Sheet: /
File: spin-tgd-power.kicad_sch

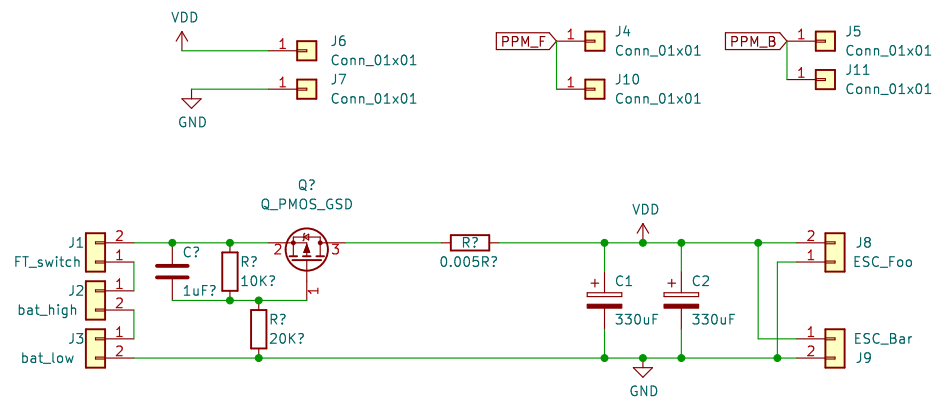
Errata:
JUST FLIP AN ESC UPSIDE DOWN TO FIX TOPOLOGY ISSUES
Investigate using traces with vias for high current
10mm 2oz traces on both layers should carry enough current
OR route all non-trace wires (2.5mm) on back side
raise signal wire ziptie holes
XT-30 FP polarity is wrong

$70A/4096 = 0.017A$ per div, but you def need an amp for this.
